May 13, 2014  
ADDENDUM #1  
PLAYGROUND IMPROVEMENTS AT  
LAKEVIEW, OAKLAND DRIVE AND BICENTENNIAL PARKS

The following information is provided regarding questions asked at the pre-proposal meeting held May 13, 2014.

SHEET NO. 6
PROJECT NAME: PLAYGROUND IMPROVEMENTS AT OAKLAND DRIVE AND BICENTENNIAL PARKS PORTAGE, MICHIGAN		
DATE: 4/23/14	SCALE: NOT TO SCALE	PROJECT #: 1333

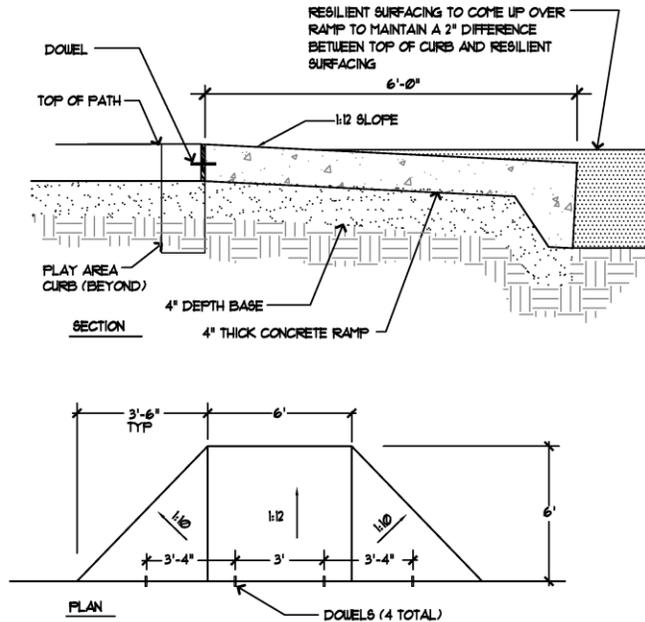
- 1) Concrete Curb & Pea Stone detail. The 6" pea stone depth is identified as the sub surface for the EWF surface area. See attached Detail Sheet #6.
- 2) Drainage holes, as referenced on Detail Sheet #7 can be placed randomly, or 12-18" on center.
- 3) Wood Chip Composting. The City of Portage Compost Site, located at 10950 Oakland Drive, will be accessible for disposal of wood chip material only. Proper disposal of all other material is the responsibility of the contractor.
